National Radio Astronomy Observatory
Charlottesville, Virginia

Dec. 24, 1981

Subject: Surface panel and the Feed Support Structure

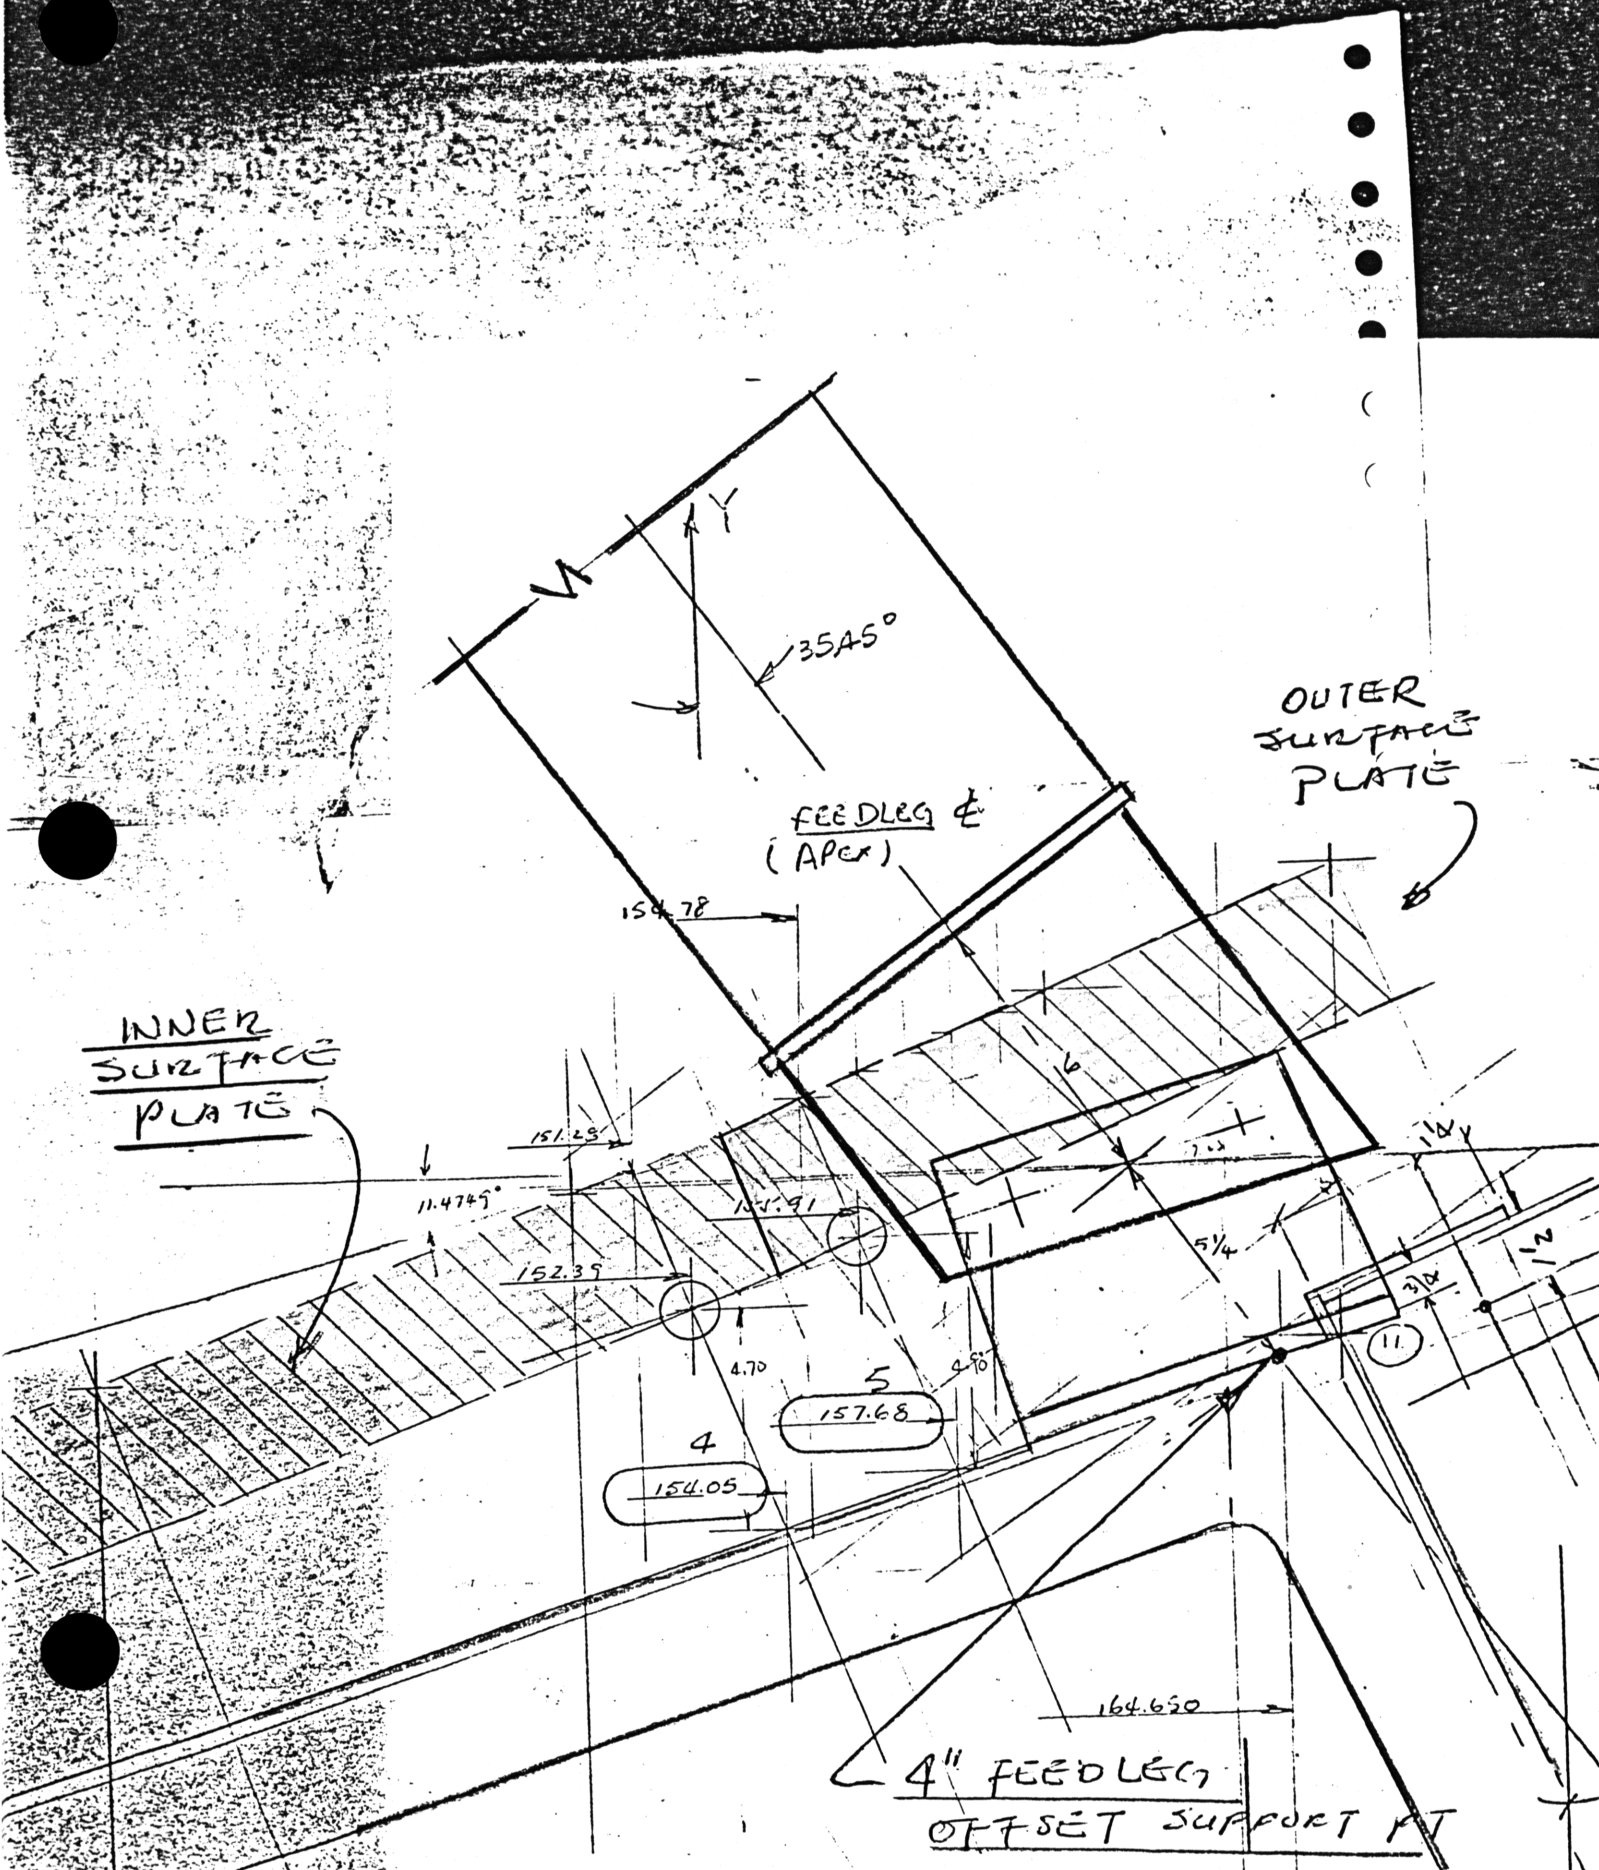
The relative locations of the feed support and the surface panels are shown on p.2. A 5" by 13" corner of an outer panel needs to be removed at each feed support. Total of four outer panels are effected. Additional panel supports may be provided near the cut-offs to increase panel stiffness.

DWG # 86 D 00127 (2/4) (A)

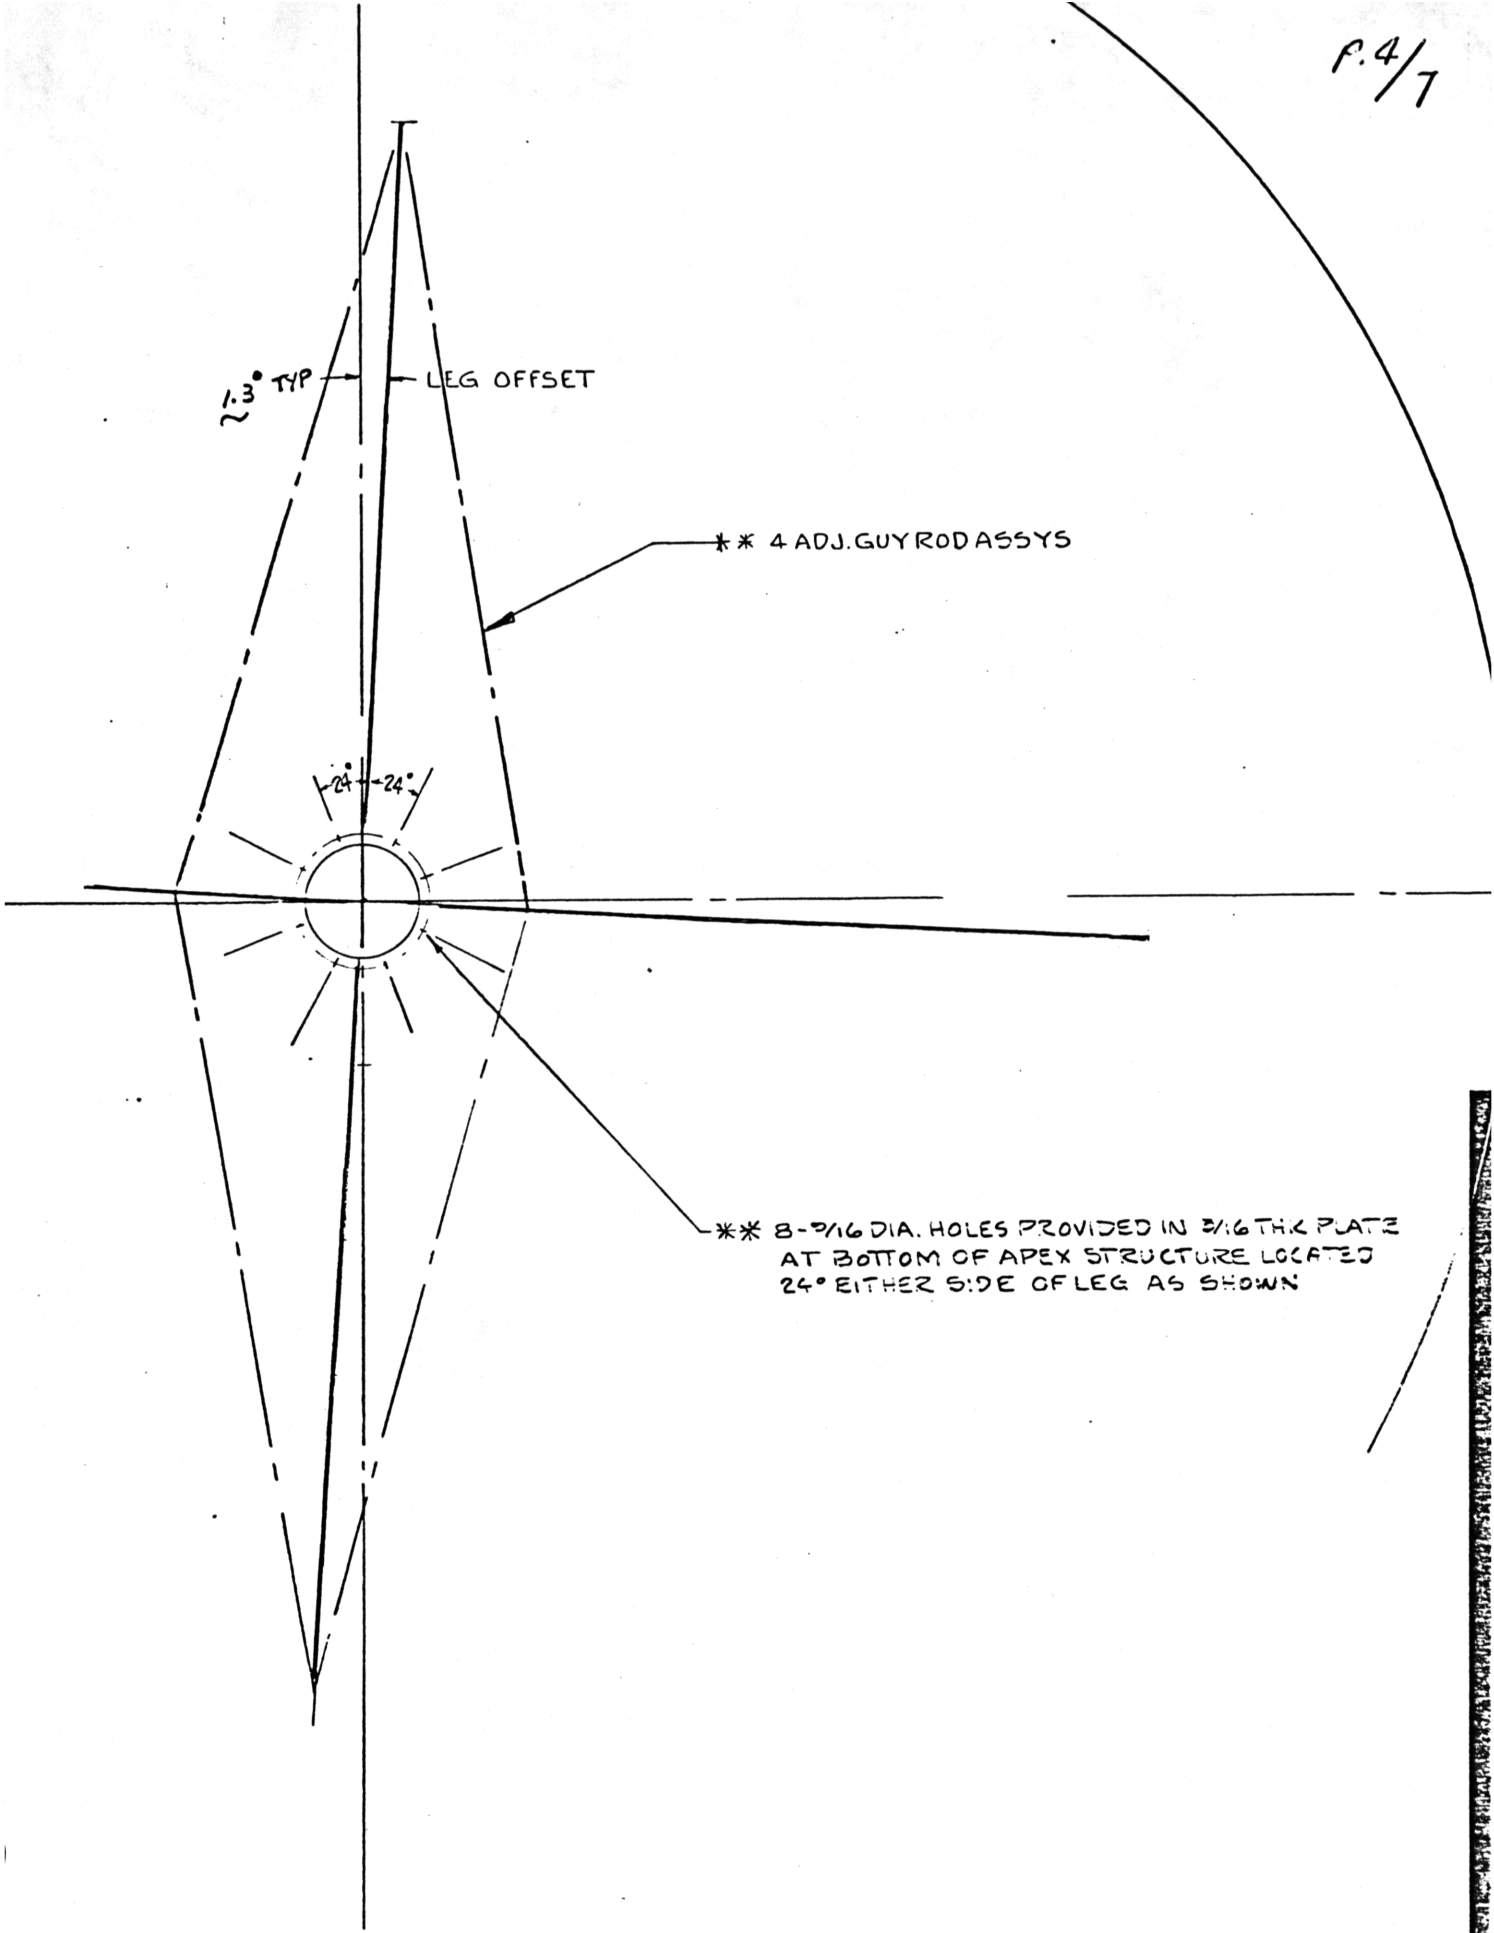
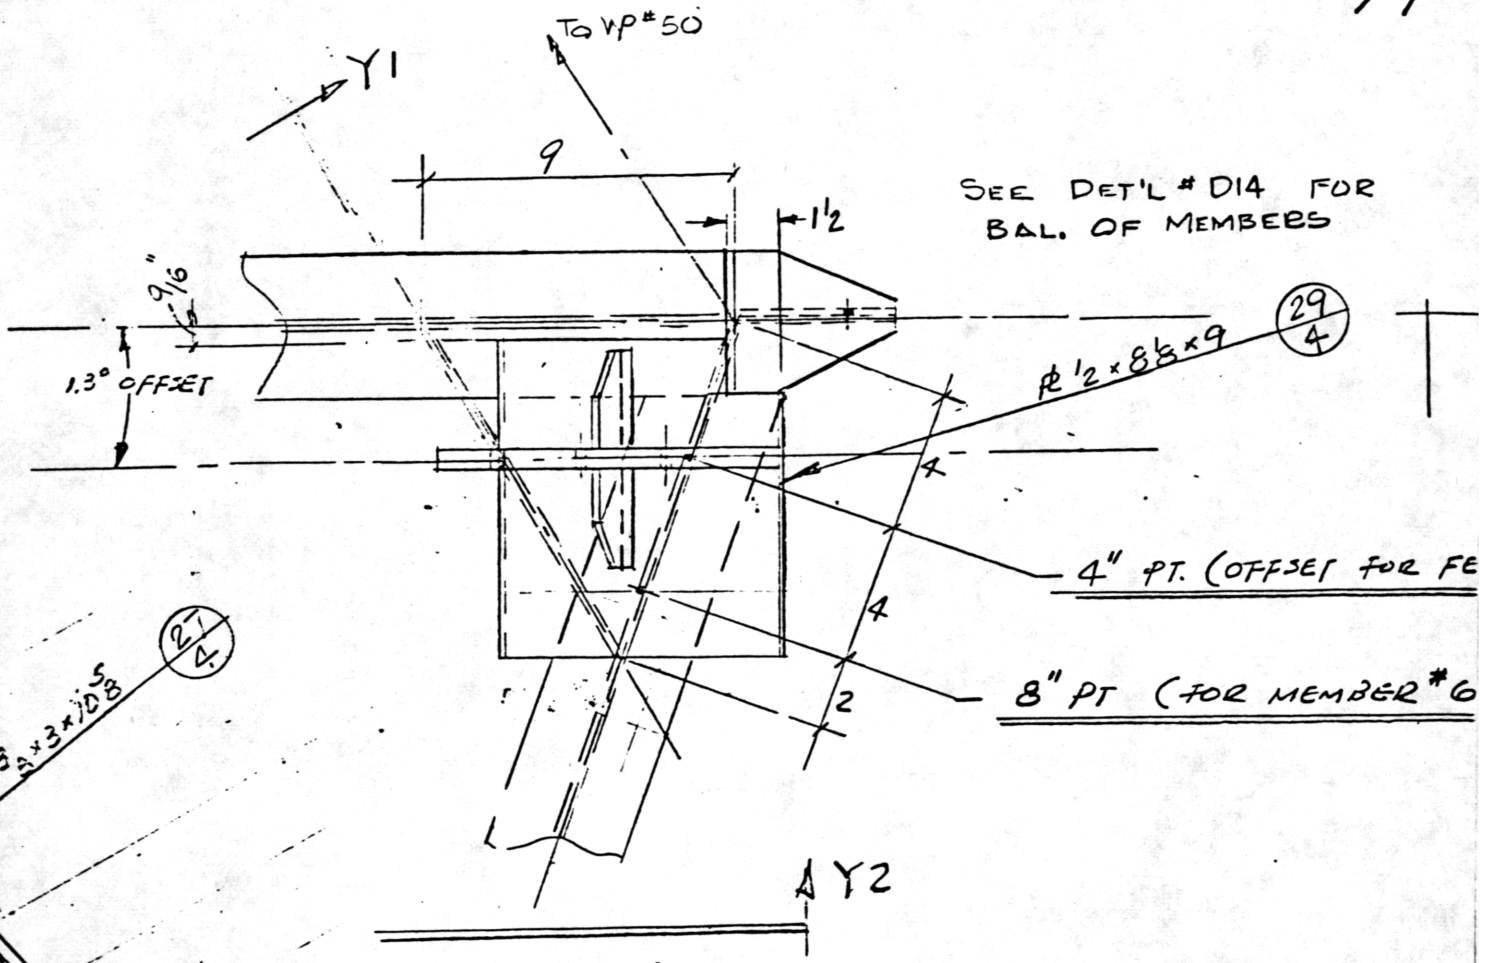
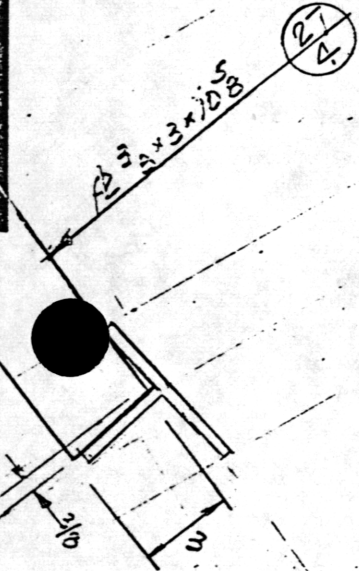
I have revised the backup structure drawings to incorporate:

- 1) the 5.50" apex height increase, and
- 2) the reduced feed structure offset angle of 1.3 degrees.

NEED SUPPORT LEGS
OFFSET 2.77° C'WISE
FROM SYM &
